Accessibility Audit and Plan

School:	Stanwick Primary Academy
Address:	Church Street, Stanwick, Northamptonshire, NN9 6PS
Website:	www.stanwick.northants.sch.uk
Phone number:	01933 623117
Principal:	Mrs Chloe Neild CNeild@stanwickprimary.org.uk
SENDCo:	Mrs Kerri Connolly kconnolly@stanwickprimary.org.uk
Site & Facilities:	Mr Lee Butterworth (Site Supervisor) lbutterworth@stanwickprimary.org.uk Mr Rob Alexander (Estates Manager) ralexander@neneeducationtrust.org.uk

Audit completed by:	Karen Stevenson, Trust SEND Lead, kstevenson@neneeducationtrust.org.uk
Audit and plan date:	11.09.2023
New audit and plan due:	11.09.2026

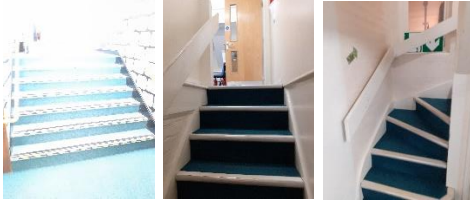
On the site there is directional signage to the main reception. Greater signage at the back entrance would be helpful to show this is the accessible entrance. There is a directional sign to the main office on this route. 			
Movement around the site	At the accessible entrance, a good pathway leads to the school. The pathways around the school are all in relatively good condition. There are some slabs which vary slightly in level leading from the Y3, Y4 and Y5 classrooms which should be monitored to ensure it remains even. Where the path has a slope near the dining room this should be identified.	Improvement recommended	Mark the beginning of the slope on the side access pathway near to the dining room door to show a change in gradient.	
Ramps and entry doors	There are no ramps on the site. Some entry doors have a step which is identified with a nosings and handrails where required. A	Improvement recommended.	*It may be useful to obtain a portable ramp for use if needed.*

ramp would be needed to make some doorways fully accessible. Some nosings in doorways have faded. Some entry doors have contrasting coloured door handles but not all. 		Ensure all nosings are clear where there is a change in height in doorways. Paint door handles a contrasting colour so these can be more easily seen.	
Playground surfaces including drainage	The playground surface is mostly of a good condition. There are some dropped drains which require nosings to be added.	Improvement recommended	Add nosings to the two drains on the walkway from the KS2 classroom to the field.
